APPLICATION NO.	FILING DATE	FIRST NAMED INVENTOR	ATTORNEY DOCKET NO.	CONFIRMATION NO
10/792,068	03/03/2004	Oswald Friedmann	588.1017	4230
23280	7590 01/09/2006		EXAMINER	
DAVIDSON, DAVIDSON & KAPPEL, LLC 485 SEVENTH AVENUE, 14TH FLOOR			RODRIGUEZ, SAUL	
	. NY 10018	OOR	ART UNIT	PAPER NUMBER
	•		3681

Application No.	Applicant(s)			
Office Action Summary		10/792,068	FRIEDMANN ET AL.			
		Examiner	Art Unit			
		Saúl J. Rodríguez	3681			
Period fo	The MAILING DATE of this communication appears on the cover sheet with the correspondence address Period for Reply					
WHIC - Exte after - If NC - Failu Any	ORTENED STATUTORY PERIOD FOR REPLY CHEVER IS LONGER, FROM THE MAILING DANSIONS of time may be available under the provisions of 37 CFR 1.15 SIX (6) MONTHS from the mailing date of this communication. Operiod for reply is specified above, the maximum statutory period we are to reply within the set or extended period for reply will, by statute, reply received by the Office later than three months after the mailing ed patent term adjustment. See 37 CFR 1.704(b).	ATE OF THIS COMMUNICATION 36(a). In no event, however, may a reply be tim will apply and will expire SIX (6) MONTHS from cause th

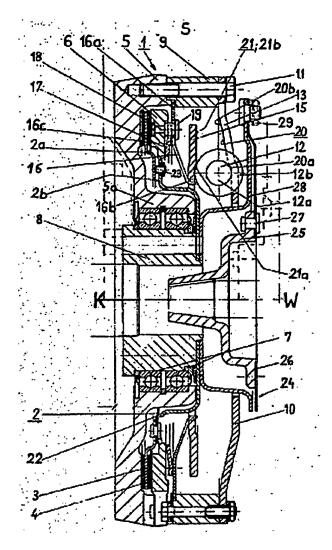
Claims 1-5 and 10-13 are rejected under 35 U.S.C. 102(b) as being anticipated by DE ('377).

DE discloses a lever system (Fig. 1) for a motor vehicle comprising a lever (15) with portions and points, a radially displaceable fulcrum (12), an energy storage mechanism (16) including a disk spring, a pressure plate (6), a flat/smooth running surface, and concave surface portion.

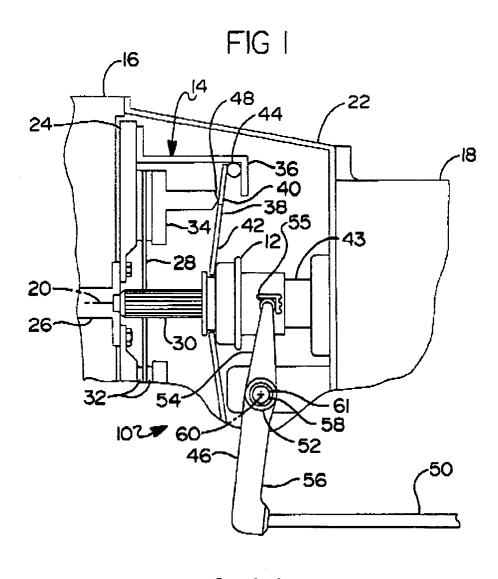
Claims 1-5 and 14-20 rejected under 35 U.S.C. 102(e) as being anticipated by Cole et al. ('517).

Cole discloses a lever system (Fig. 1) for a motor vehicle comprising a clutch (28), a lever (radially projecting cantilever nest/support corresponding to roller/fulcrum 55), a fulcrum (55) moveable radially through its arcuate motion, a second lever or disk spring (38), first axial bearing (12), and a pair of aligned roller bodies (55 – Fig. 2).
